ATLANTIC DIVISION
 NAVAL FACILITIES ENGINEERING COMMAND
 NORFOLK, VIRGINIA 23511

SUBJECT TO THE REQUIREMENTS OF
 CONTRACT NO. N62470-77-C-7526

FLORIDA STEEL CORPORATION
 "Steel when you want it"

NO.	PRINTED	DATE	STRUCTURE
102	APPD	6-5-79	To 5 BED HOSPITAL
	APPR		LOCATION
	FINAL APPR		CAMP LEJEUNE, N.C.
	FINAL APPR		CUSTOMER
	FILE #		CARDINAL CONST CO.
	FIELD		ARCHITECT
	FIELD		LOCKWOOD-GREENE-SIX ASSOCIATES
	FIELD		ENGINEER
	FIELD		DO
	FIELD		DESCRIPTION
	FIELD		SEWAGE PUMP STATION DETAILS

AN AT EL. - 8.76 - BOTT. BARS

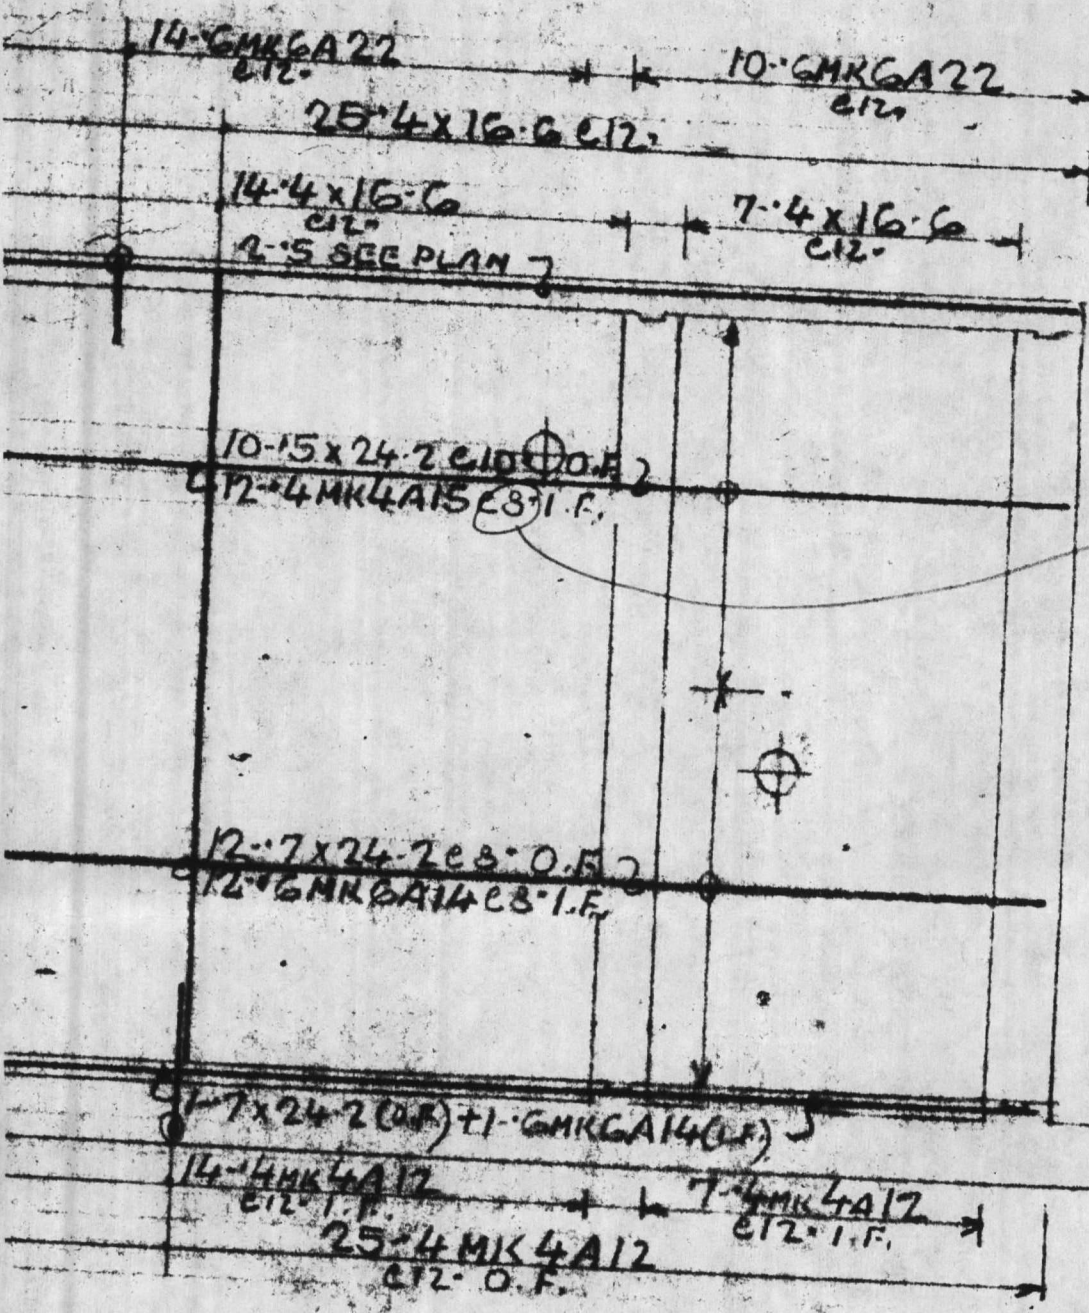
10" SPCG SHOWN
 OK TO LEAVE
 @ 8" RB
